Re: Yeshivath Viznitz
 Special Permit Application
 235 Elm Road, Briarcliff Manor, NY

Yehivath Viznitz 235 Elm Road
Colliers Engineering & Design Project No. 21003367A

The following items are in response to comments in Provident Design Engineering (PDE) memorandum dated June 30, 2021.

Proposed Travel Route, Bus Dimensions, Turning Movement Diagrams

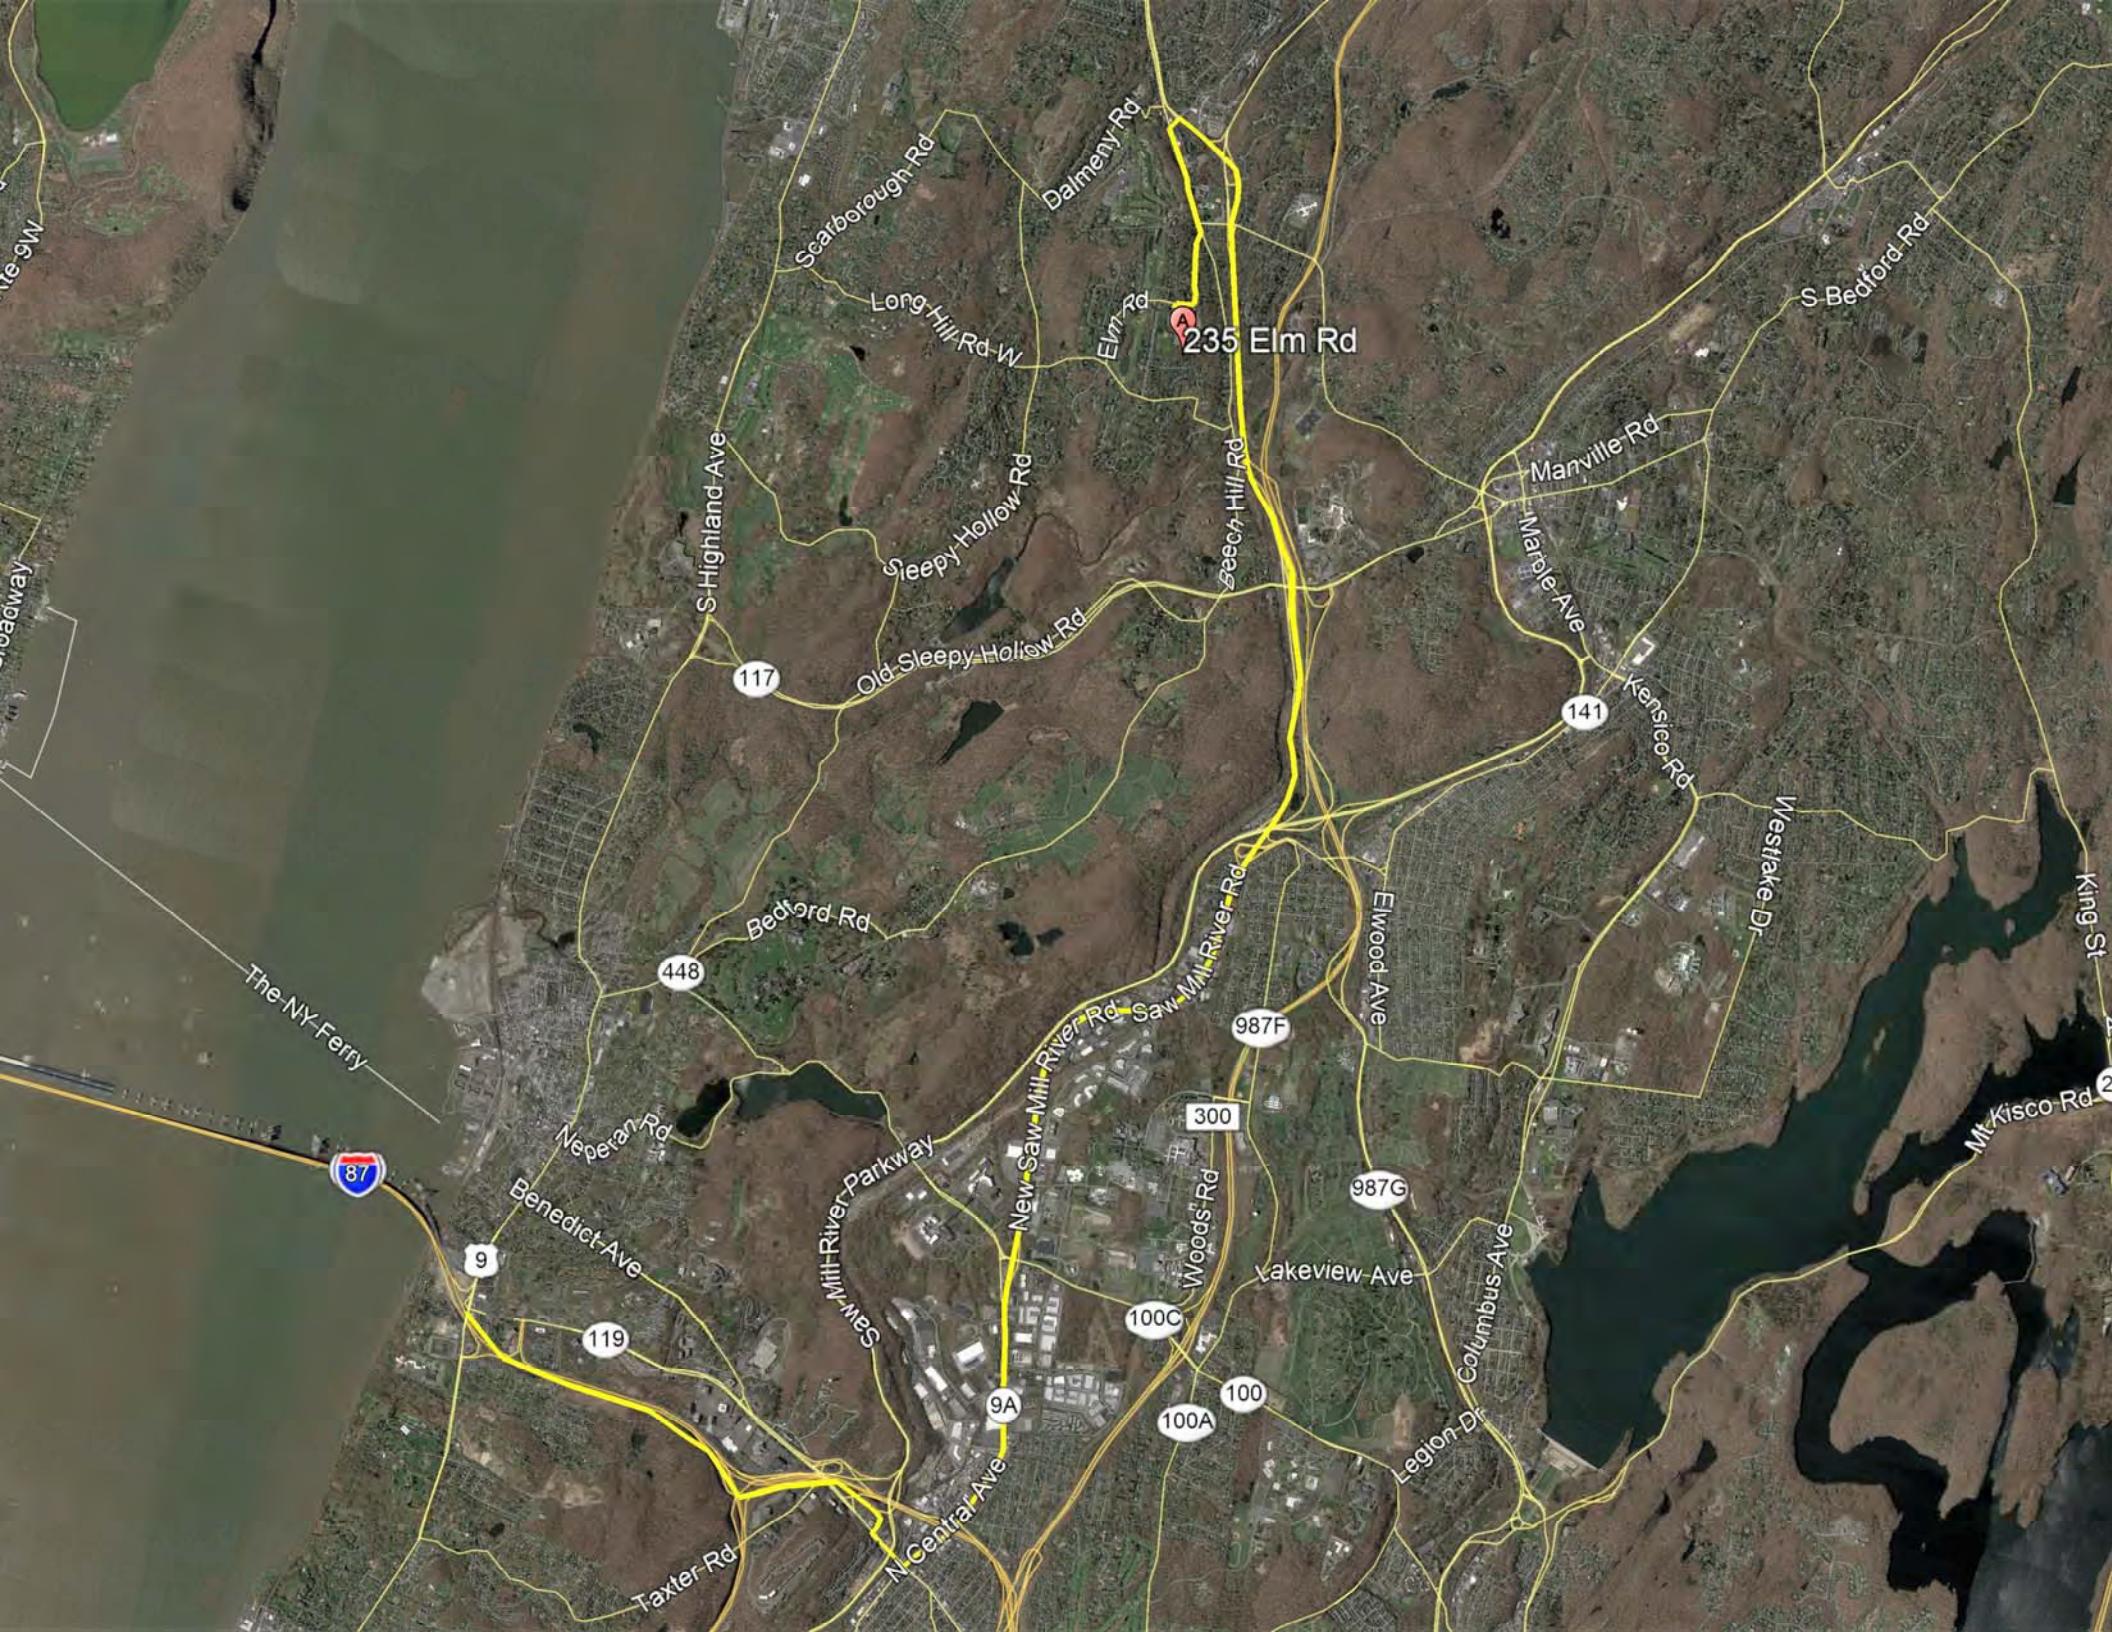
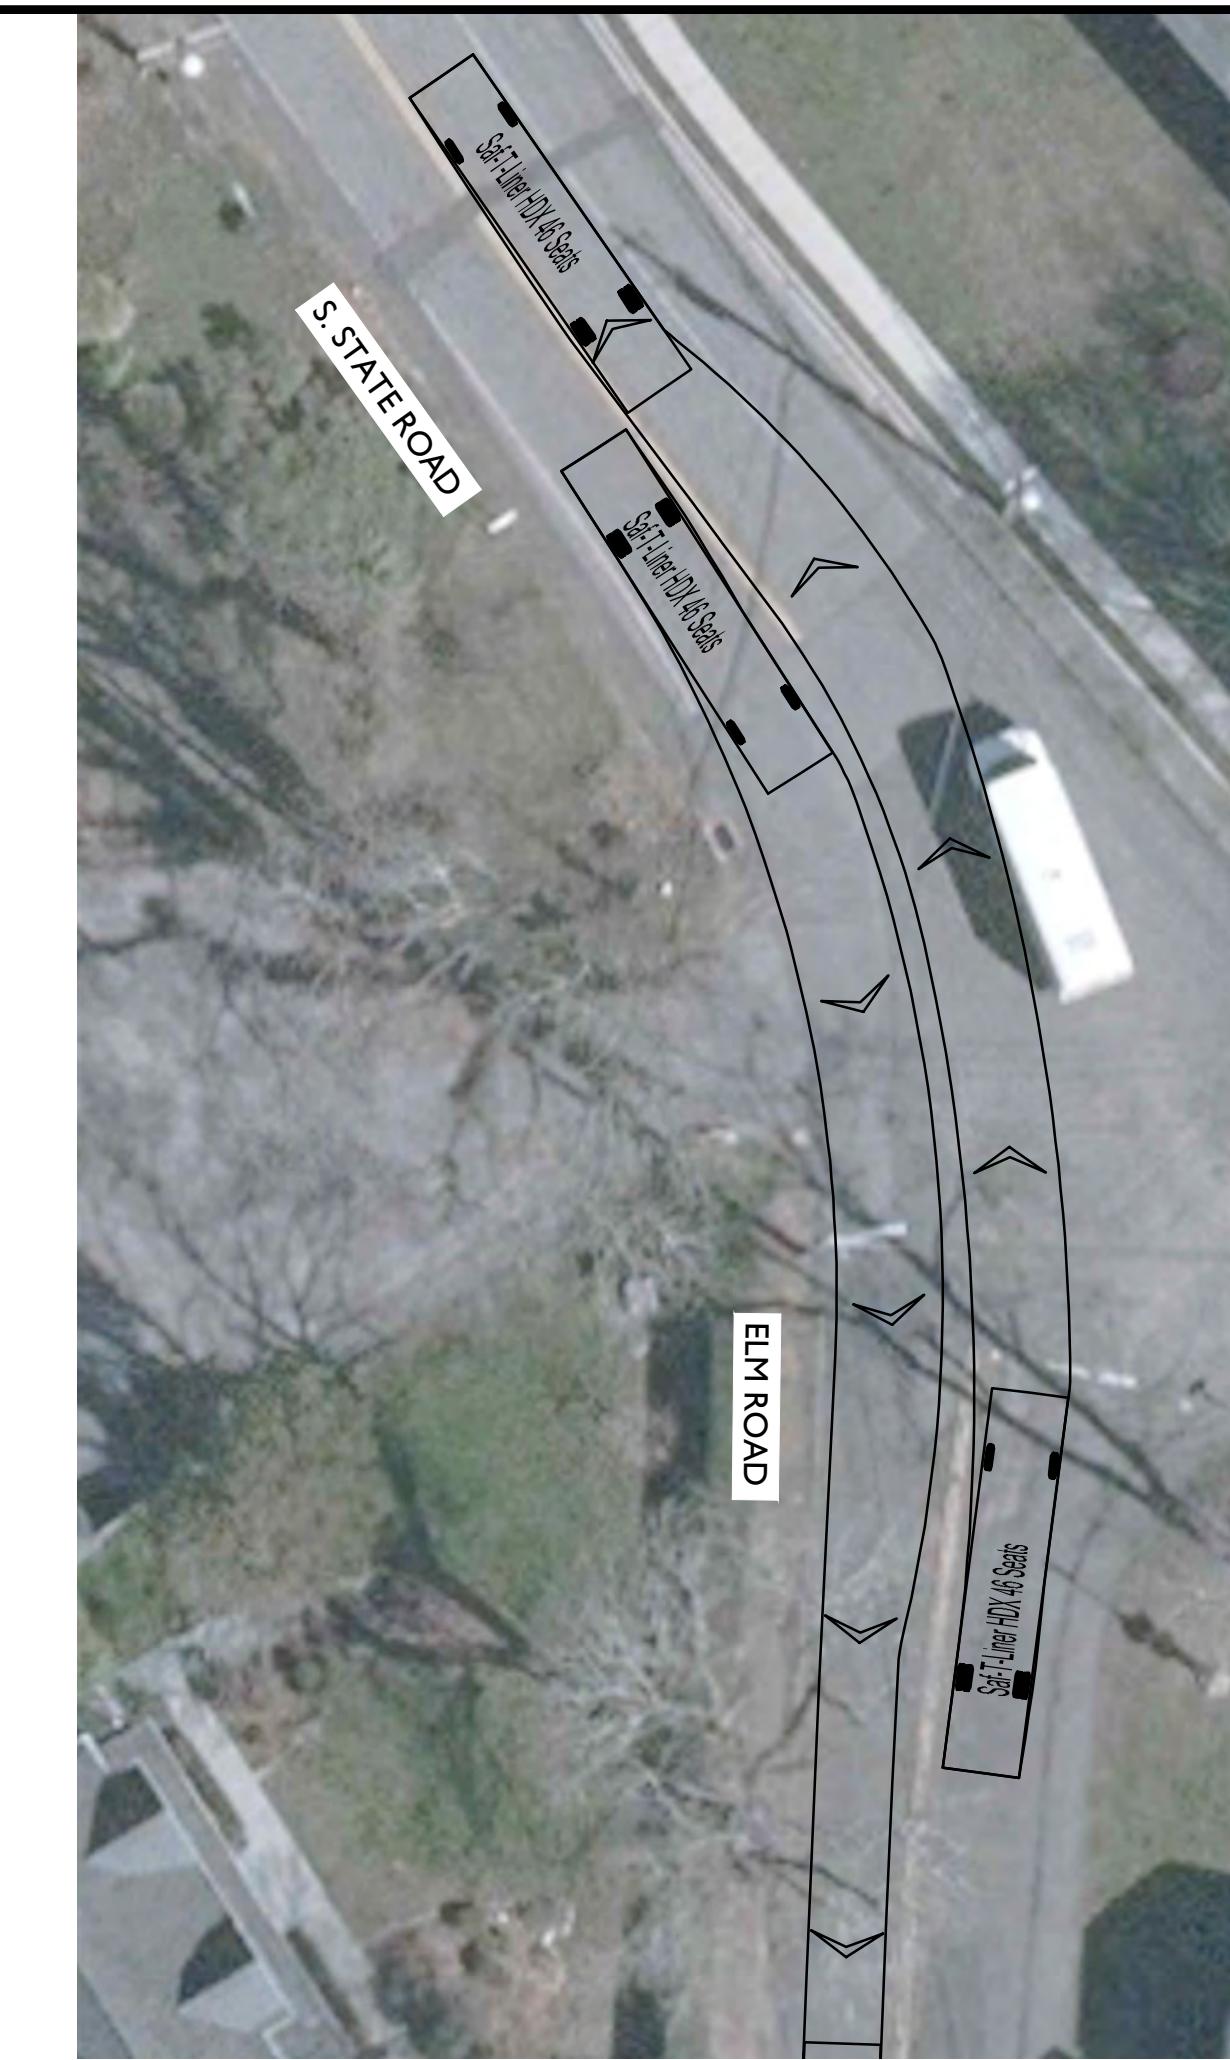
3. If full size buses are to be utilized, what are their origin locations, and their proposed routes should be provided. Buses are not permitted on the Taconic State Parkway or the Saw Mill River Parkway. In addition, vehicles from northbound NY Route 9A are not permitted to turn left onto Pleasantville Road. For the proposed routes, for any locations in the vicinity of the Site where there are tight turns, a turning maneuver diagram should be illustrated for a full-size bus including, but not necessarily limited to, the Site Driveway, the intersection of Elm Road/South State Road (depending upon the direction of travel), the left turn from Pleasantville Road onto the southbound Route 9A Ramp, and the U-turn ramp just prior to entering onto southbound Route 9A. Also, it should be confirmed that the school bus can travel under the Route 9A bridge under Pleasantville Road.

Response: The full-size buses proposed are the 2020 Thomas HDX Commercial bus with 46 seats. Turning movement diagrams for various travel routes to/from the site using the U.S. Route 9A and NYS Route 9A corridors including the site driveways were conducted using the proposed full-size bus dimensions. Based on a review of the turning movement diagram, it was determined that full size buses should be directed to use the NYS Route 9A Corridor. A copy of the proposed travel route, proposed full size bus dimensions and turning movement diagrams are contained in Attachment A. See also Response 9.

SIGHT DISTANCE PLAN

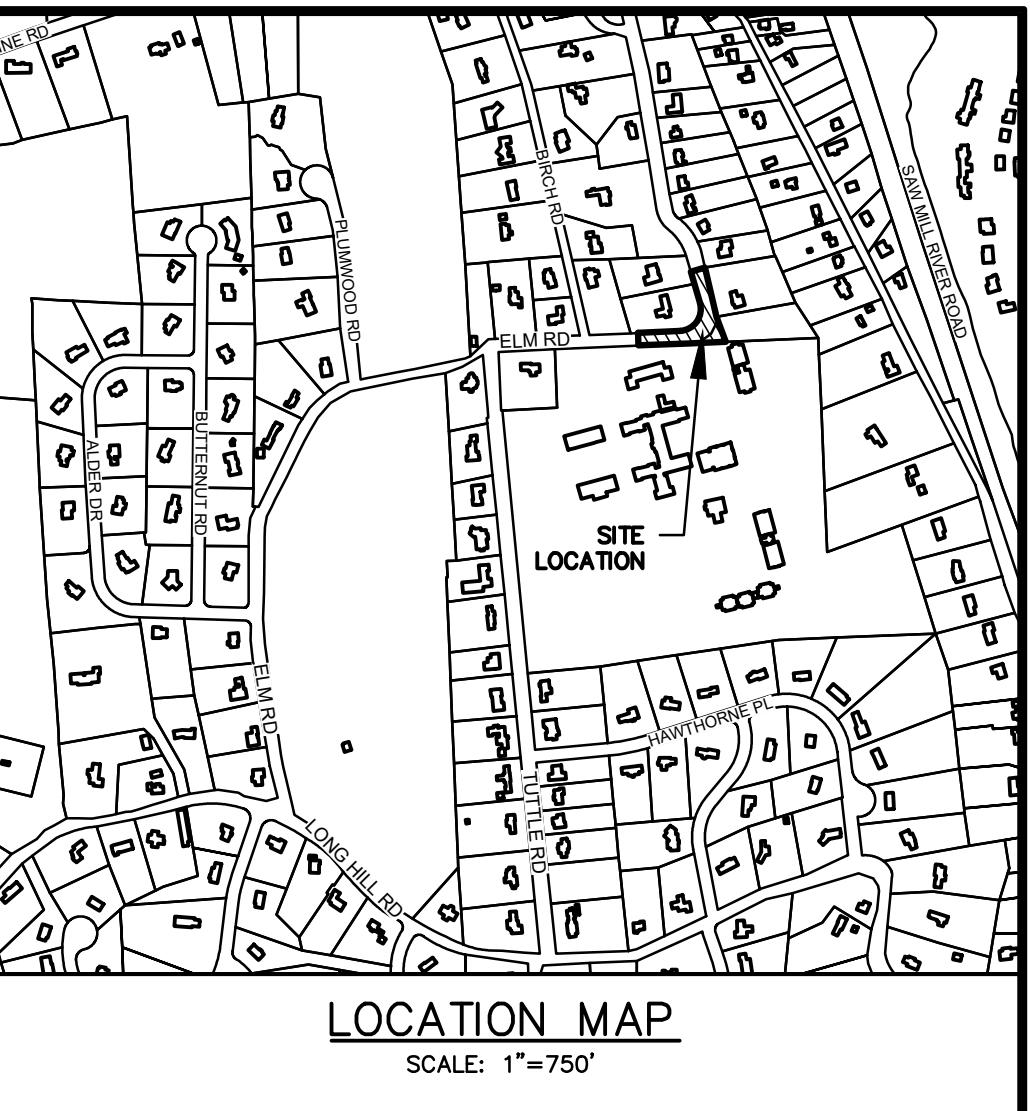
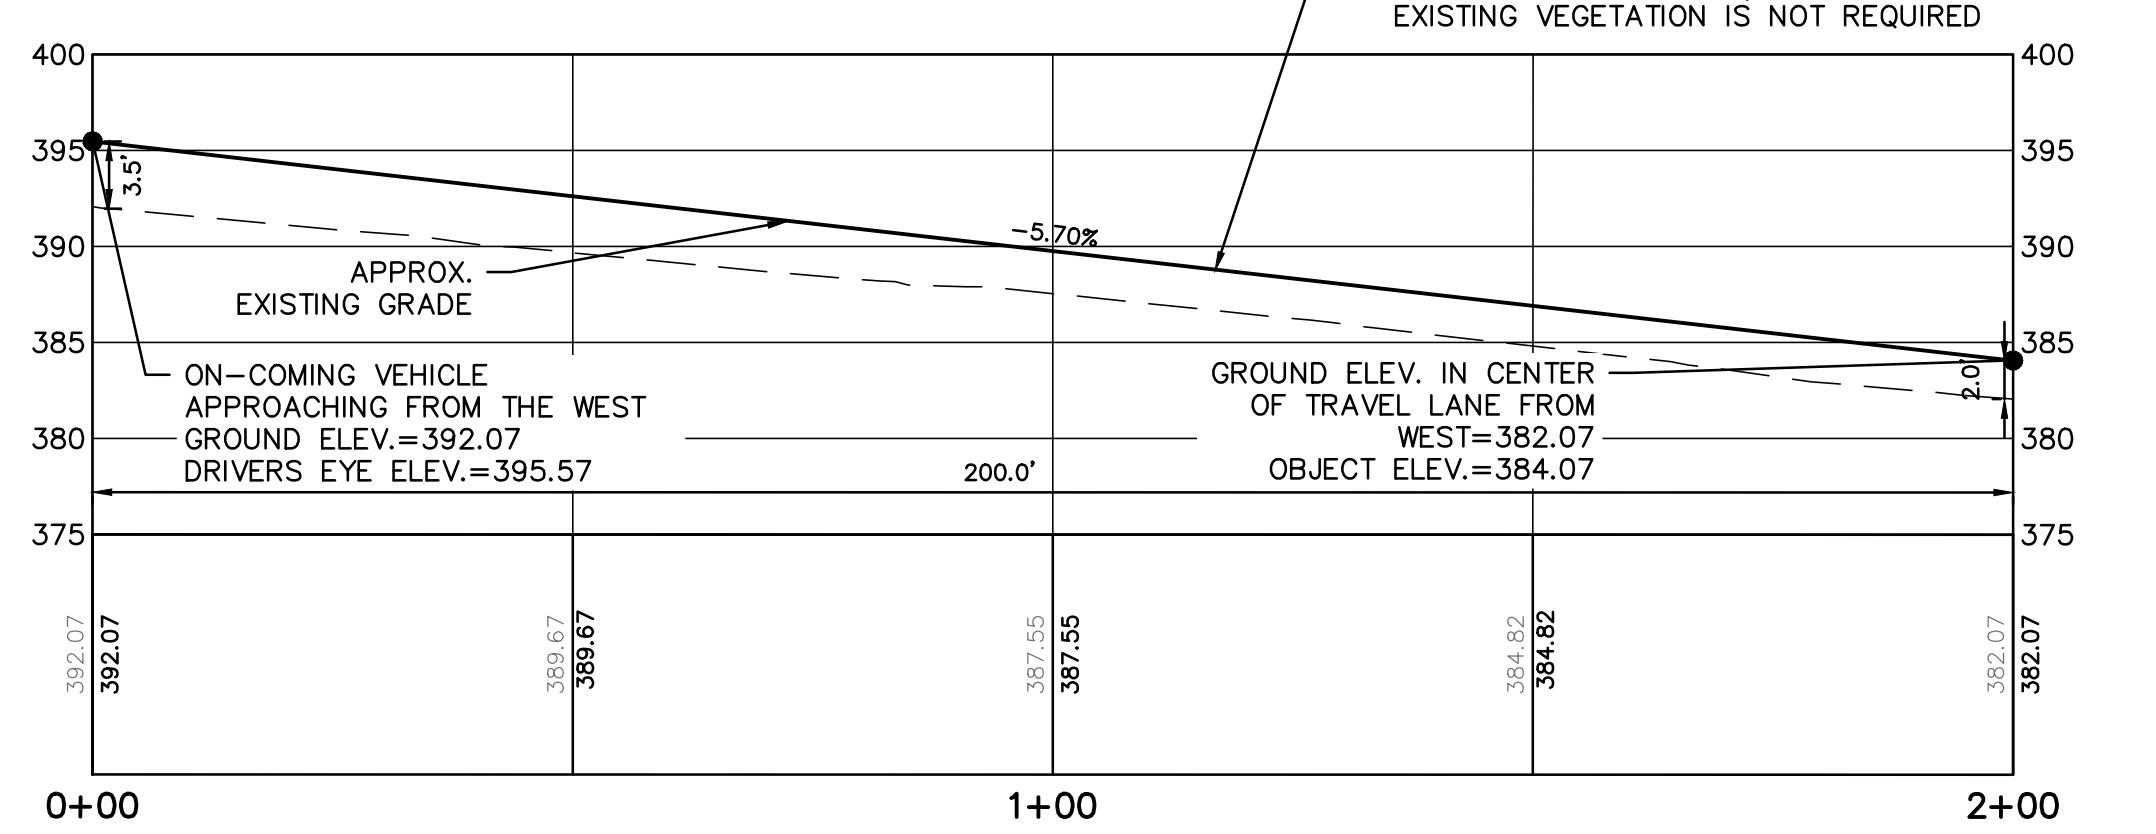
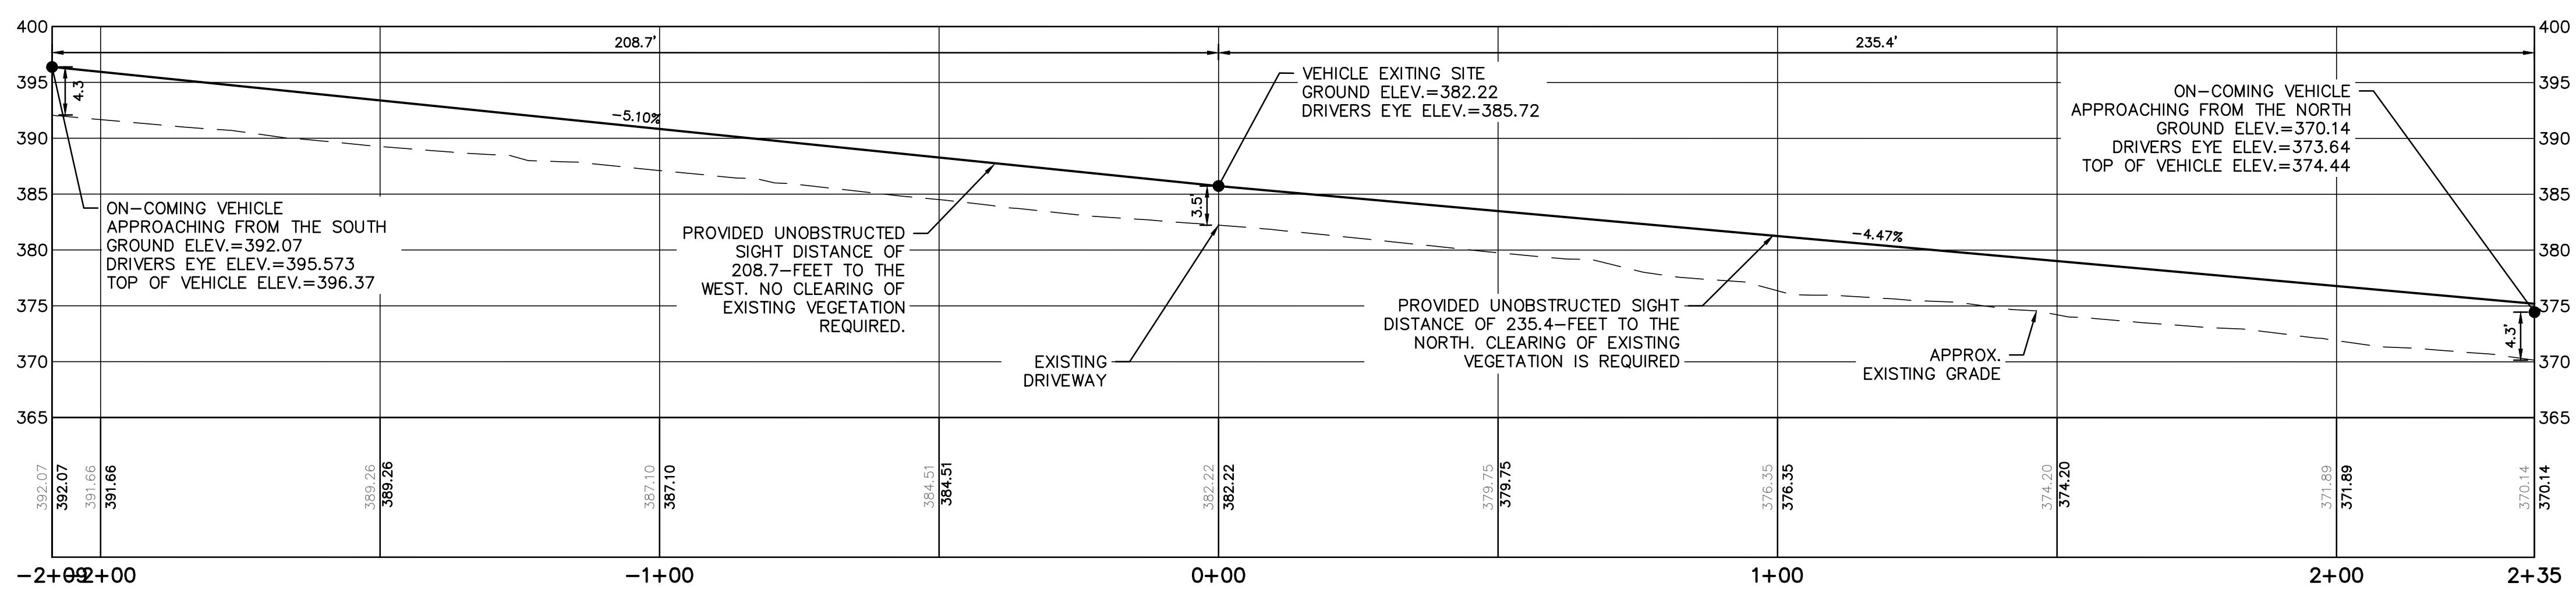
14. The sight distance at the Site Driveway should be reviewed prior to construction and opening to determine if any vegetation needs to be cleared.

Response: The Applicant has prepared the Sight Distance Diagrams included on Page SD-1 of the Site Plans prepared by Hudson Engineering and Consulting, P.C. dated 8/18/2021. The Sight Distance Diagrams demonstrate that there will be sufficient stopping sight distance from the west and from the north with selected trimming of landscaping within the Elm Road right-of-way.
